BROAD LANE, HARINGEY

TRANSPORT ASSESSMENT ADDENDUM

**REPORT REF.
2206940-R05B**

March 2025

Figure 2.1: Extract of Figure 7.1 from Manual for Streets – capacity of various carriageway widths

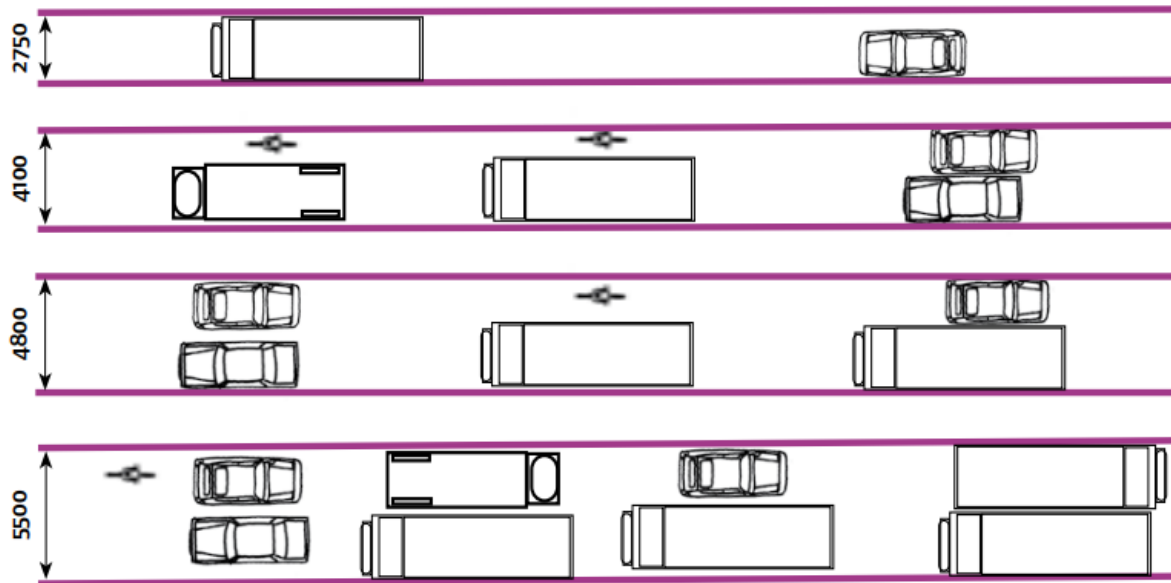
The application originally detailed the width of the service road as 5m (as detailed in the Feb 23 Delivery and Servicing plan) This led to concerns being raised by both Haringey Transportation and TfL as to the ability of vehicles to pass a dwelling delivery vehicle or refuse collection vehicle parked in the loading bay.

- 2.4. The original measurements were based on OS mapping which resulted in a discrepancy, with the topographical survey showing that there is an existing width ranging between circa. 5.9m and 7.2m.
- 2.5. In terms of the proposed scenario, the width of the road measures between 7.1m and 6.8m. There is sufficient width provided along the access road to allow for vehicles to pass the loading bay, even in instances where there is a dwelling vehicle. The carriageway width narrows to 3.86m to the north of the loading bay which is sufficient width for cars and occasional larger vehicles, as per Manual for the Streets Figure 7.1 (see **Figure 2.1** below.)

Accessible Cycles Store

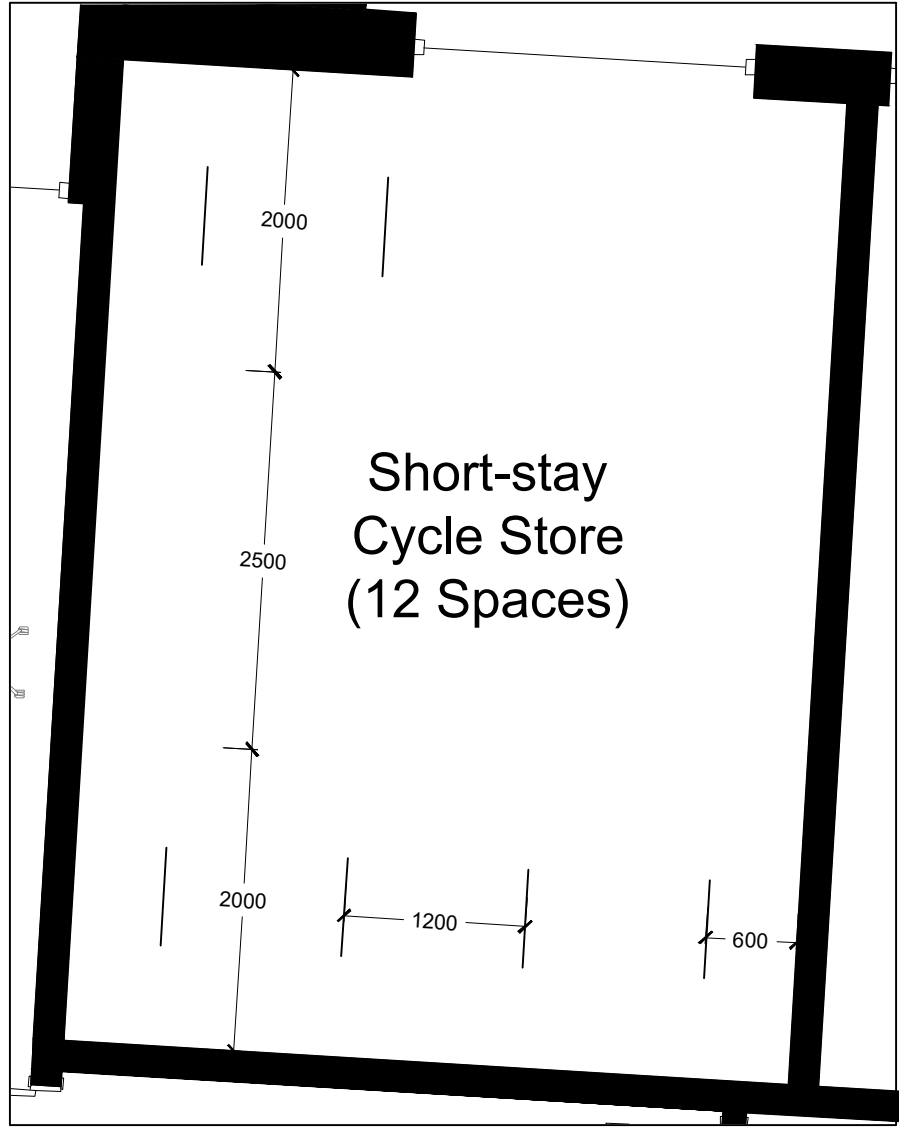
Overall, the applicant is able to exceed the London Plan minimum numerical requirements for cycle parking provision, which is of course encouraging, however prior to decision transportation should have sight of full dimensional arrangements for the cycle parking proposed including future additional provision, to ensure that high quality and convenient, attractive cycle parking is able to be delivered.

2.28. The cycle stores have been designed in accordance with Chapter 8 of the TfL document 'London Cycling Design Standards.' A summary of the dimensions adopted in the cycle stores is presented below, but also reflected in the plans contained at **Appendix B**.

Long-stay cycle store (Extended - Additional 21 spaces)

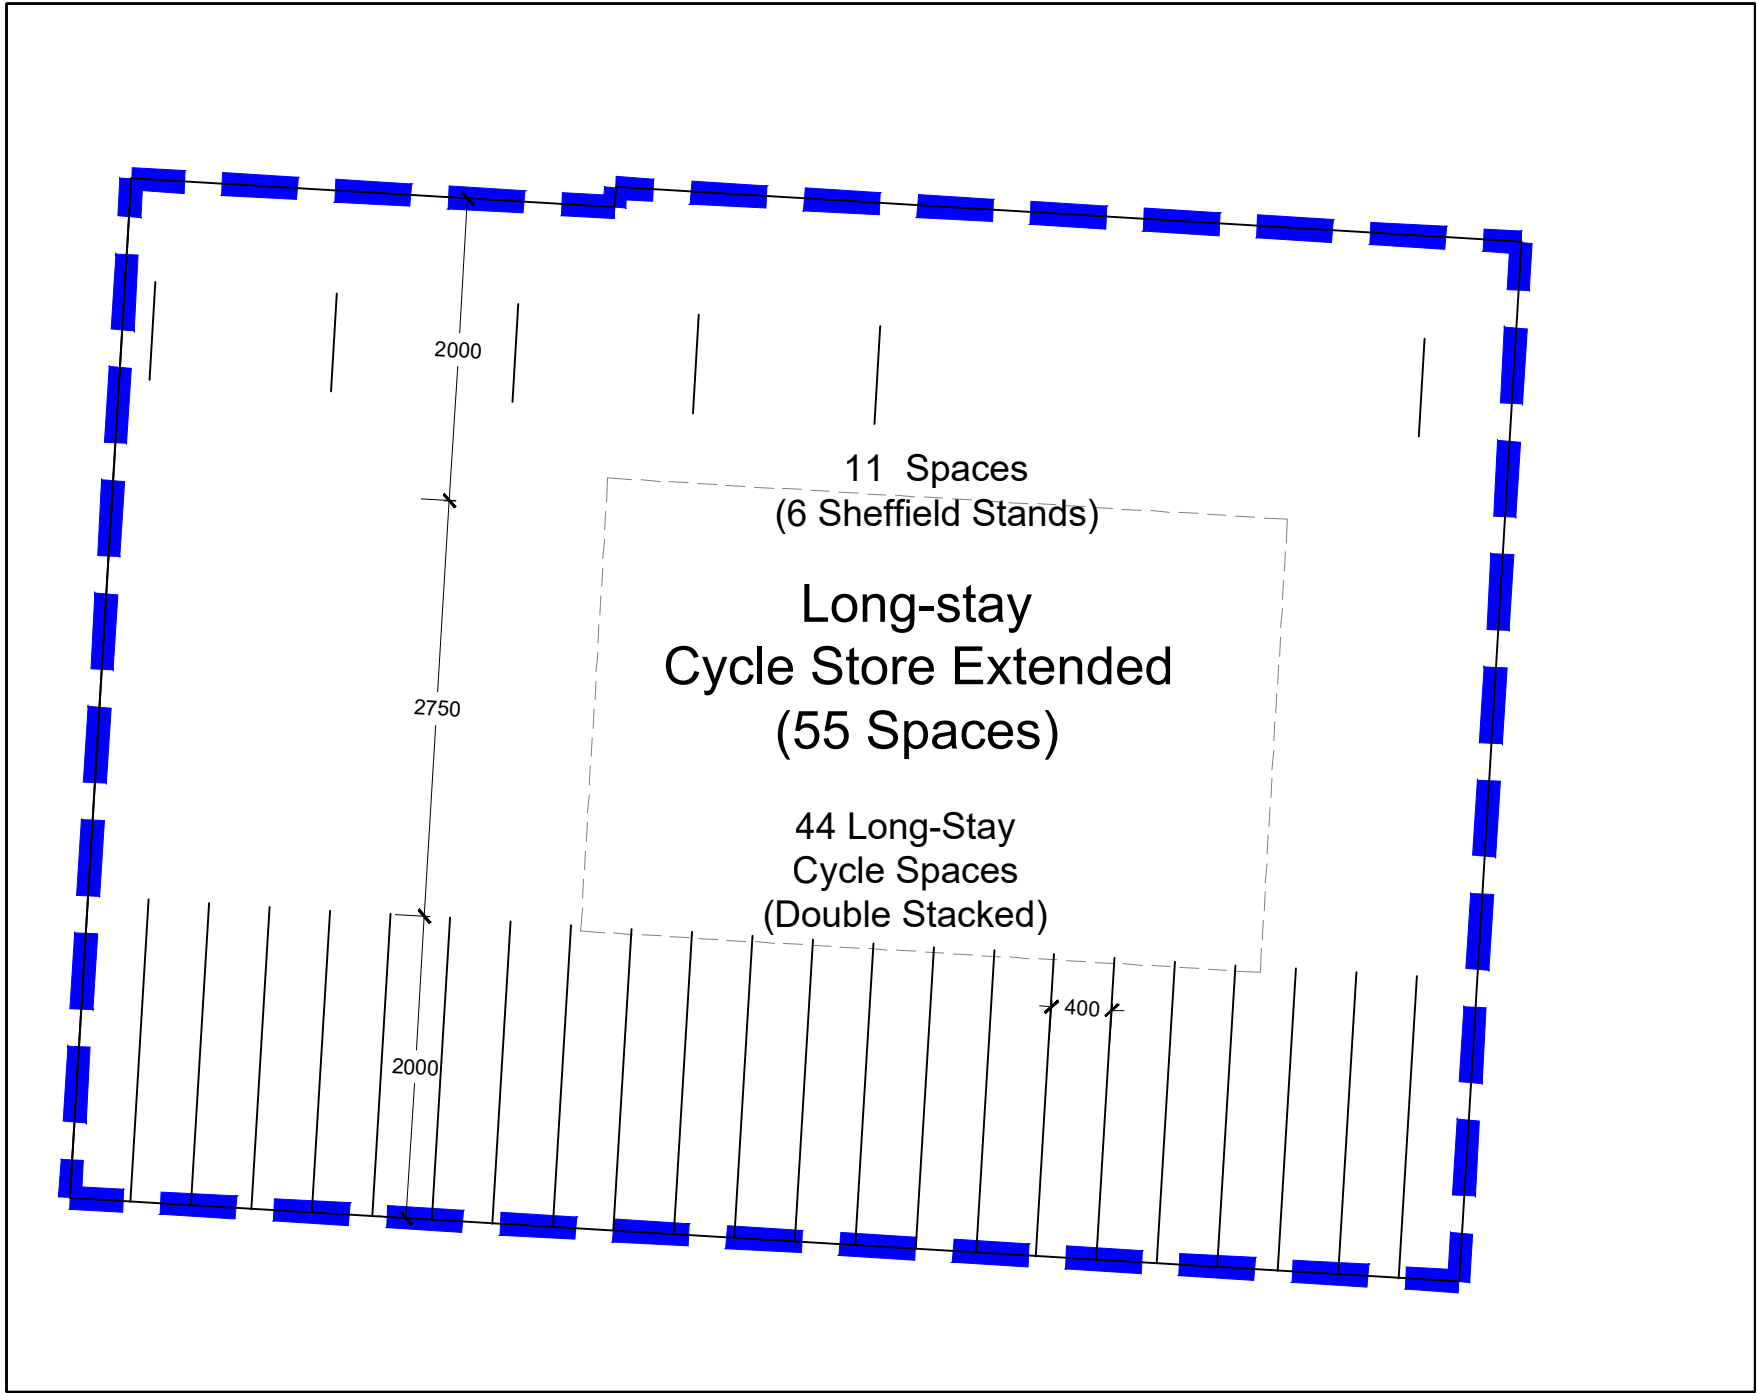
It is quite feasible that actual demands could exceed London Plan provision so the applicant needs to detail how additional cycle parking can be provided within the development to meet these future demands.

2.26. If an increase in demand for on-site cycle parking arises, then there is scope to increase provision on-site. The extended rear cycle store could provide an additional 21 cycle parking spaces, which will be provided as a mixture of Sheffield stands and two-tiered stands. The additional provision will remain in accordance with the standards set out in Paragraph 2.23.

2.27. The proposed layout of the potential future cycle parking layout is included at **Appendix C**.
